Variance Request Form

PG&E Hollister 115 kV Power Line Reconductoring Project

Variance Request No.: 7

- Attachment A: Variance 7 Proposed Shoo-fly Location Map

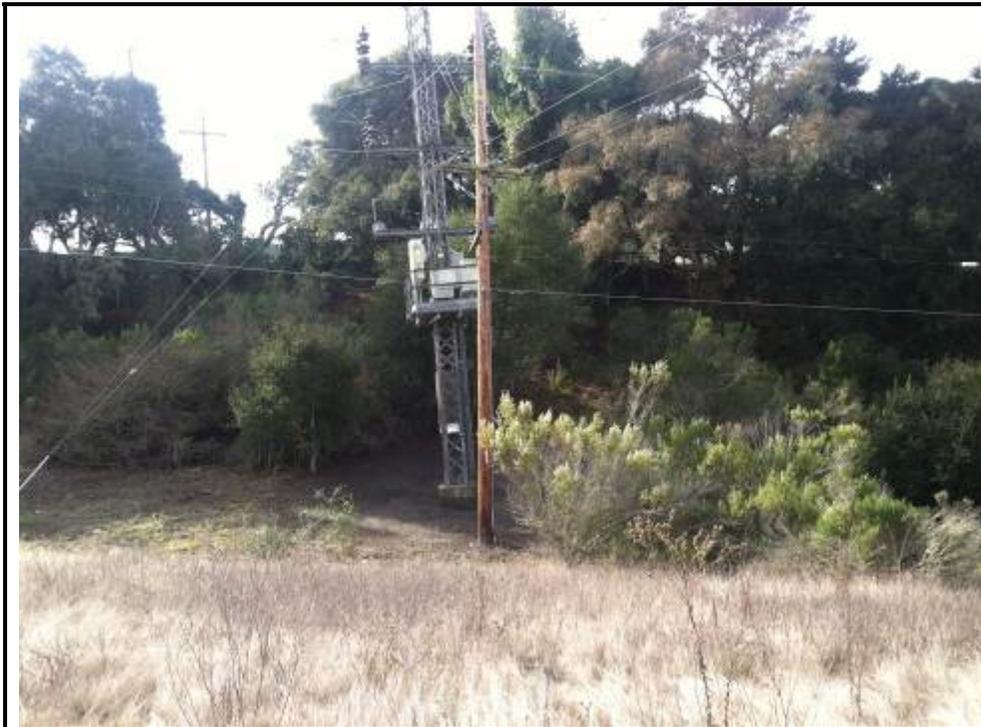
PG&E is requesting a variance for the Hollister 115 kilovolt (kV) Reconductoring Project (project) to slightly relocate the power pole shoo-fly line to the Anzar Switch Tower from the location it was described in the MND.

The new proposed shoo-fly line route will also originate from the power line that runs parallel to the project tower segment. However, the shoo-fly line would connect directly from the Anzar Switch Tower, which is located approximately 100 feet west of Pole 13/02, and then connect to Pole 13/02. The existing conductors between poles 13/01 and 13/02 would be disconnected at Pole 13/01 and moved to connect to the Anzar Switch Tower. Rerouting the shoo-fly line will eliminate the need for the three new temporary wood poles and provide a safer configuration for the construction of the new Tubular Steel Pole 13/01. Proposed construction activities will consist of two bucket trucks traveling to the vicinity of the Anzar Switch Tower to support above ground power line work on the tower. One truck would travel, via an overland access route, to a location just northwest of the Anzar Switch Tower, while the other truck would travel, via an overland access route, to a location northeast of the Anzar Switch Tower. Both trucks would be located approximately 30 feet from the shoo-fly line. The trucks would remain within these locations for approximately two hours to transfer power lines for the shoo-fly. The work area northeast of the Anzar Switch Tower would consist of an approximately 15-foot diameter area which will be temporarily covered with plastic or geotechnical fabric sheeting and gravel to provide a stable pad for the bucket truck. An area that measures approximately 15 feet by 15 feet would require brush removal at the work area northwest of the Anzar Switch Tower to allow vehicle access to the tower site. There will be no excavation associated with the construction activity because no temporary wood poles will be installed. No further activity will occur at the site until the shoo-fly is disassembled, which will occur in approximately September 2012. At that time, two trucks will travel to the site again for approximately two hours to remove the shoo-fly line and the gravel and underlying plastic or geotechnical fabric sheeting. The configuration of the shoo-fly line and the associated work areas are represented in Attachment A: Variance 7 Proposed Shoo-fly Location Map. Photographs of the proposed work area are provided in Attachment B: Photographs.

This alternative shoo-fly configuration will eliminate the need to install the three new temporary wood poles and provide a safer configuration for the construction of the new Tubular Steel Pole 13/01. Potential impacts associated with this variance are consistent with those evaluated during the CEQA review for the project and; therefore, will not result in any additional impacts. Potential impacts to special-status species and archeological resources are anticipated to be less when compared to the previous shoo-fly line configuration, as a result of eliminating ground-disturbing activities associated with the installation of three new temporary poles. Environmental protection measures will be implemented as described in the MND and other project permits.
